REPORT ON

INSTALLATION OF EXTRACTION WELL EW-13 FOR
ON-SITE GROUNDWATER EXTRACTION SYSTEM
2221 NIAGARA FALLS BOULEVARD
WHEATFIELD, NEW YORK

Design Clarifications/Modifications

| REV | DATE | DESCRIPTION | DR BY | RW BY |
|--|-------|---|-------|-------|
| DES BY: JJR | 11/97 | SHEET TITLE: EW-13 RECORD DRAWING VAULT PANEL | | |

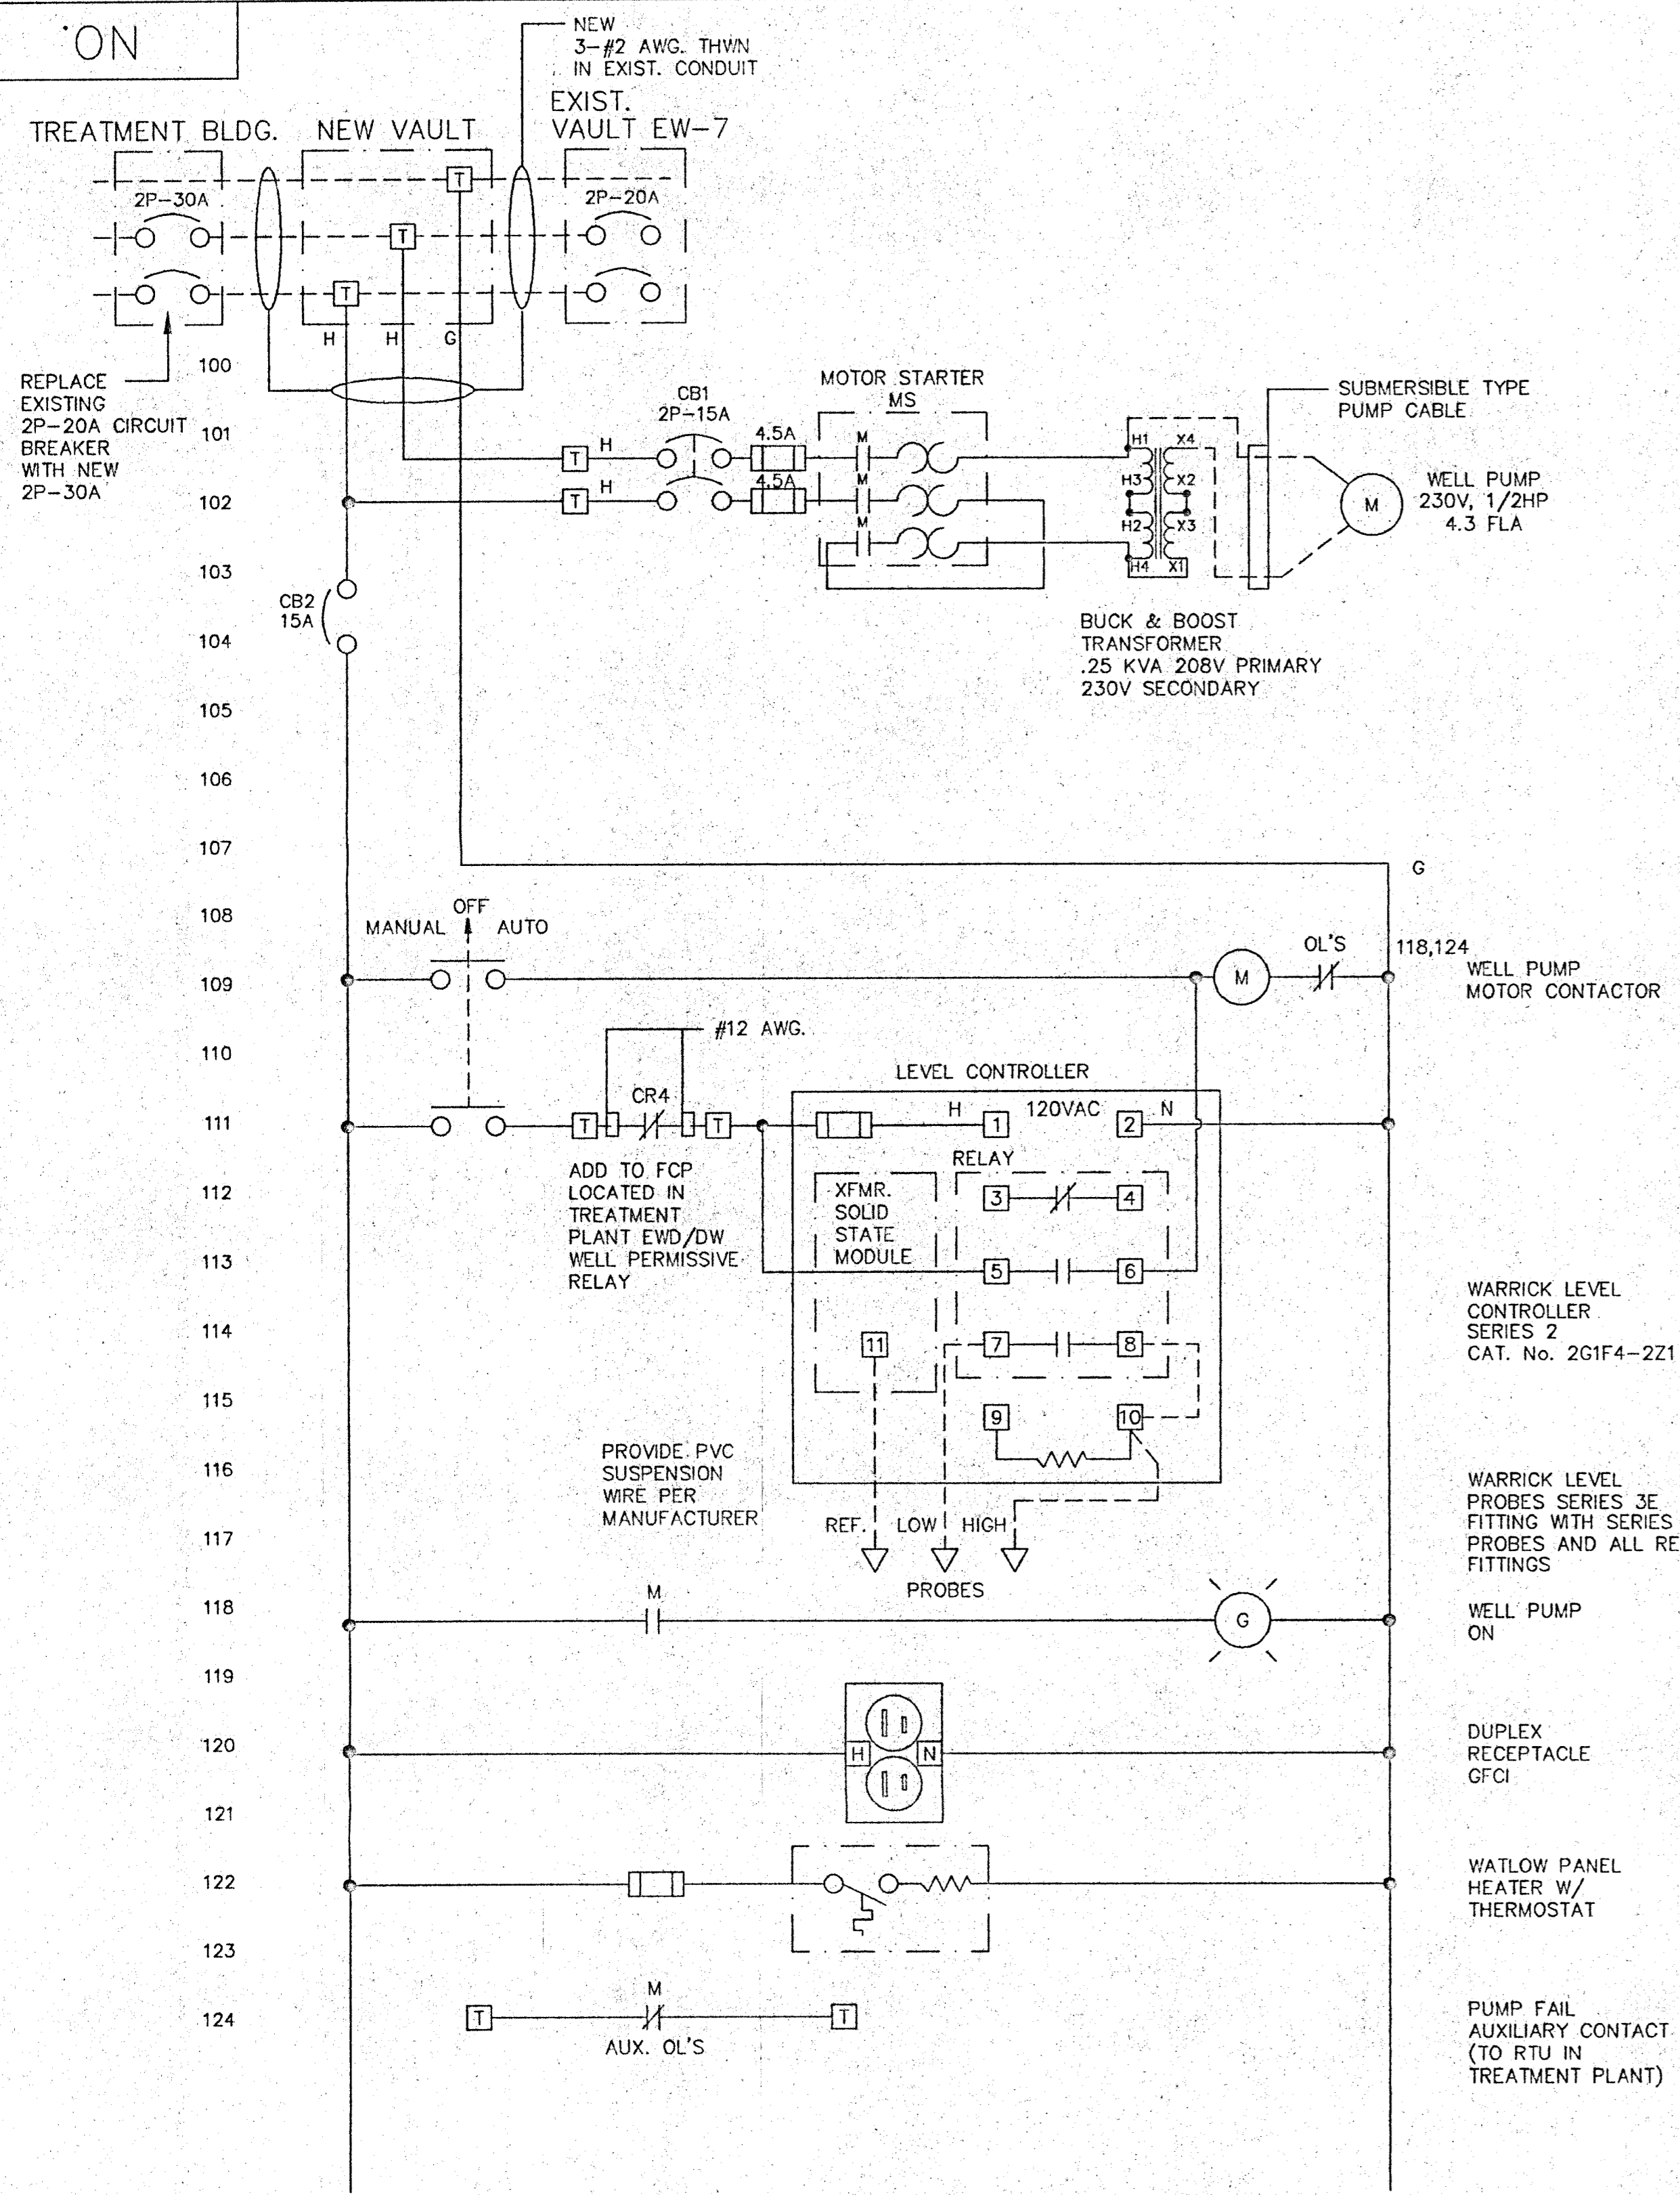
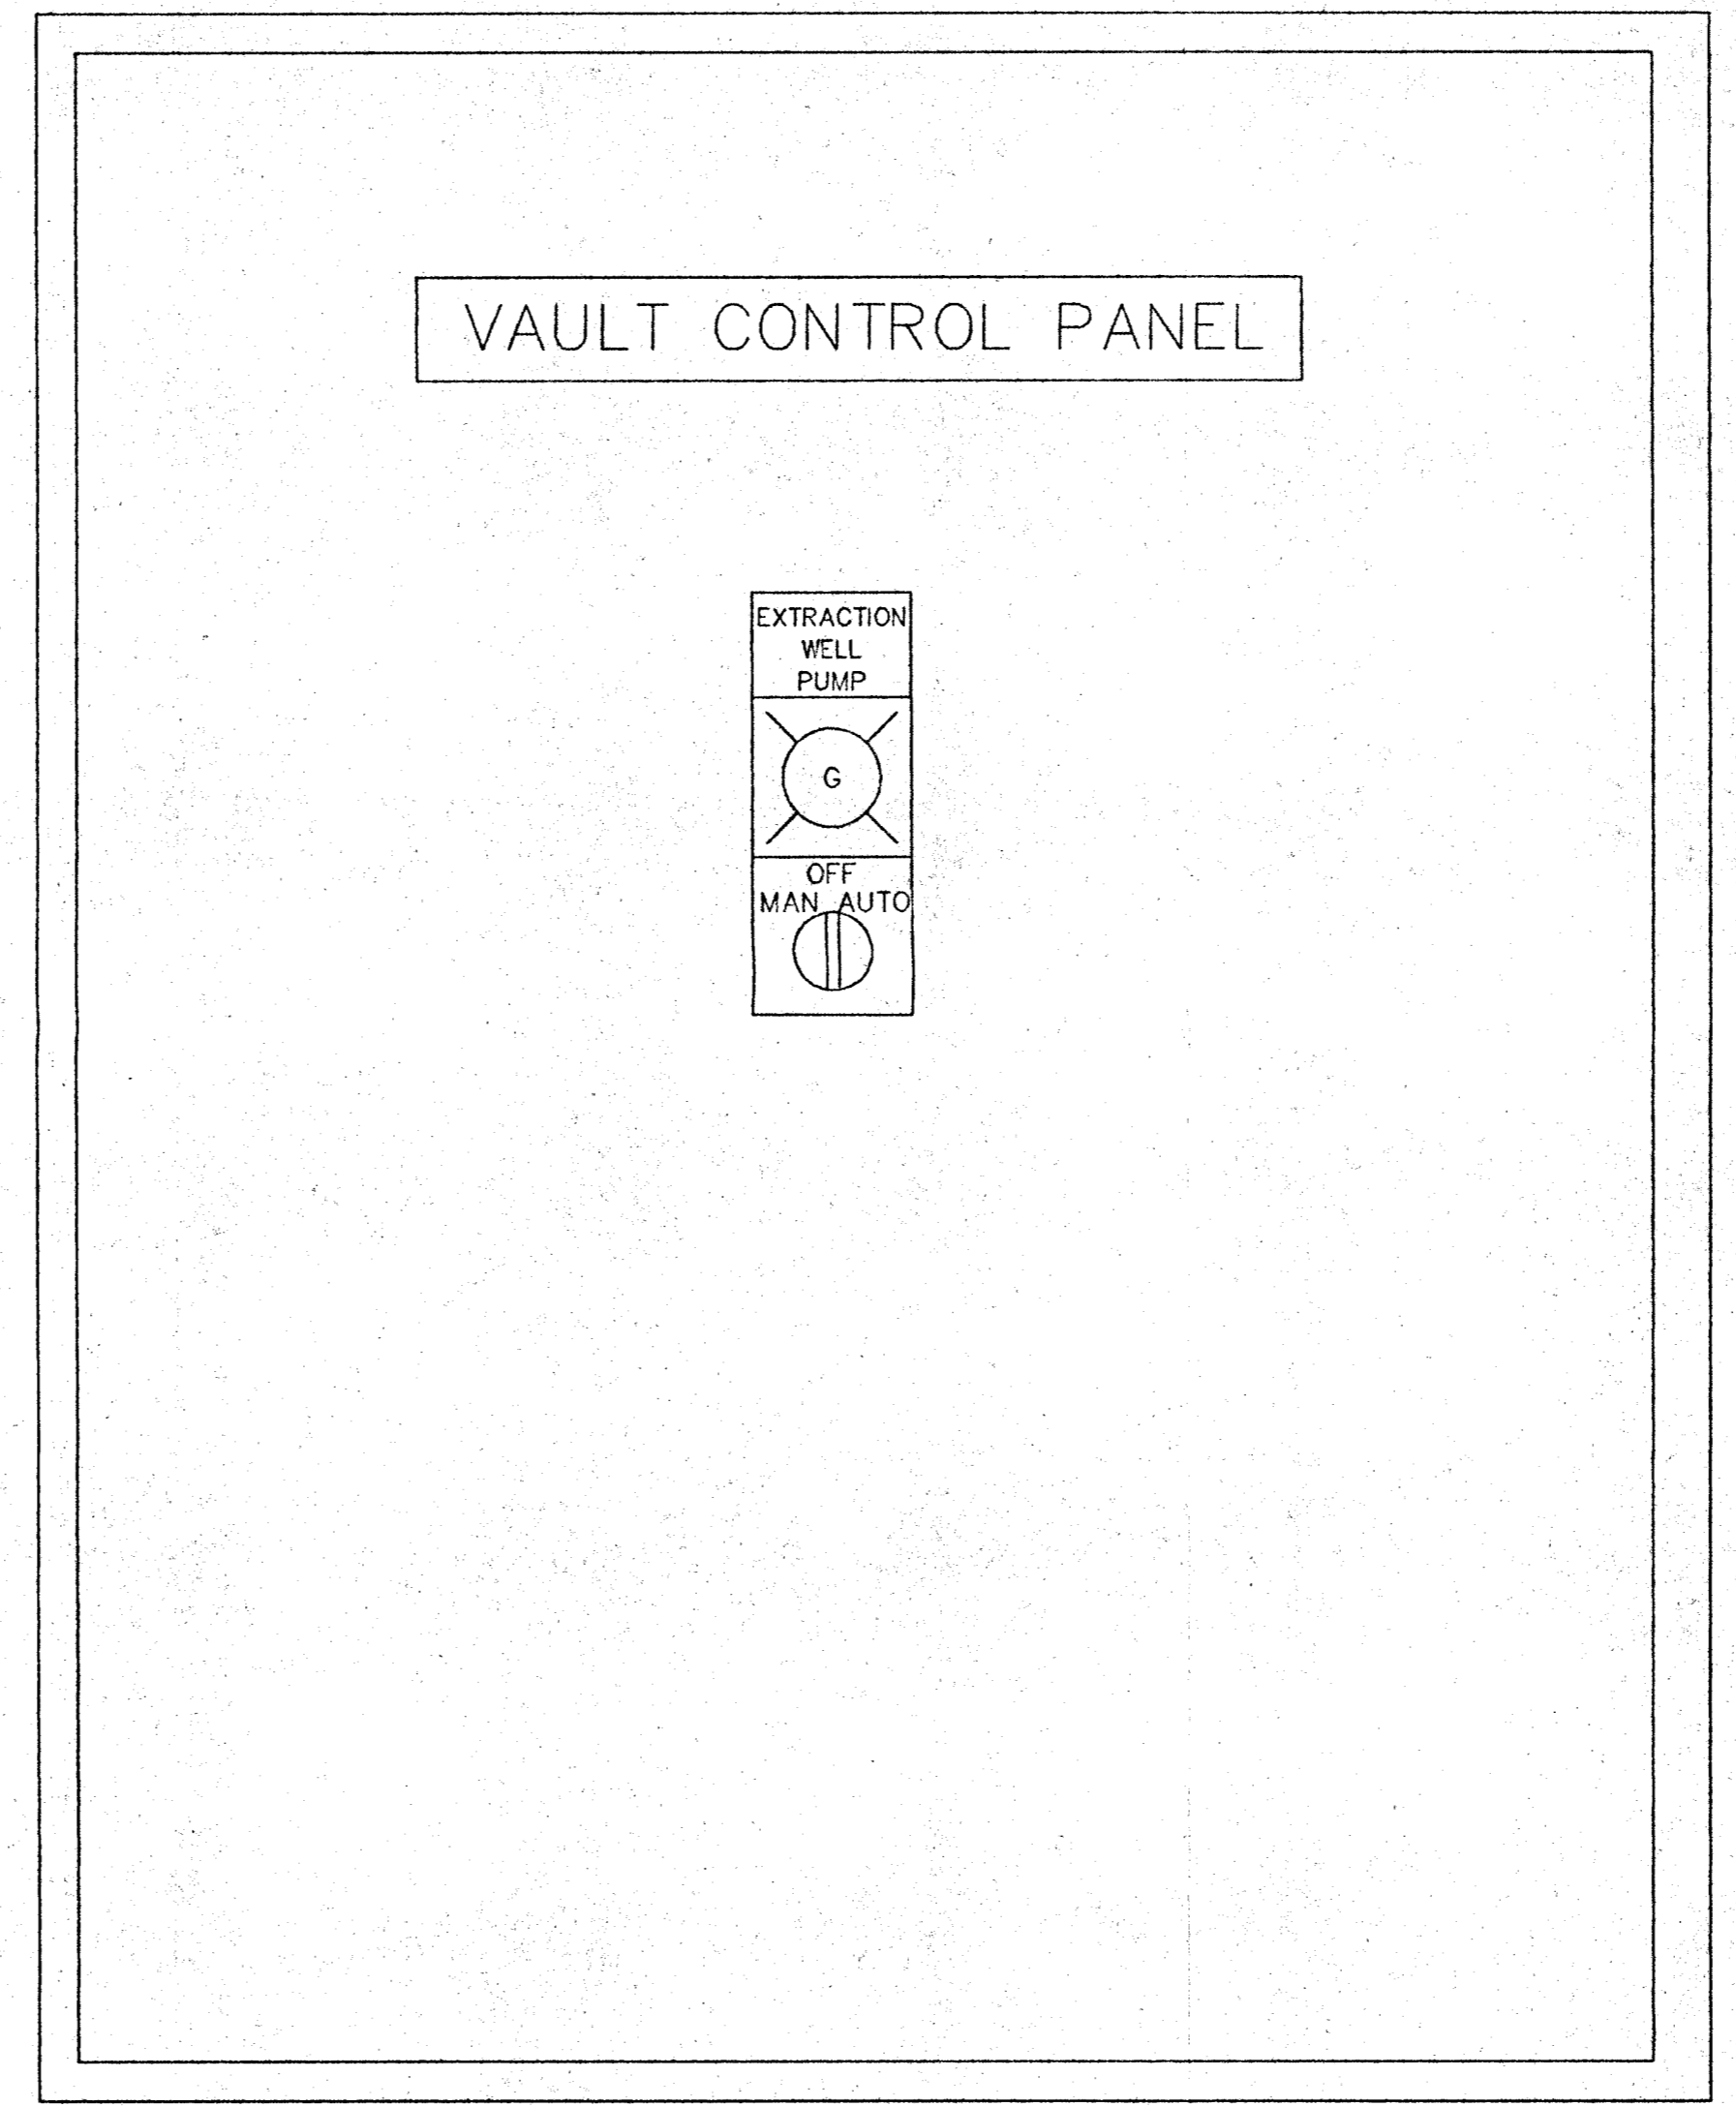
LOCATION / REFERENCE OF MODIFICATION: Drawing E-2

MODIFICATION MADE: Warrick controller specified, No. 2D1F4-2Z1, is incorrect; correct catalog number is 2G1F4-2Z1
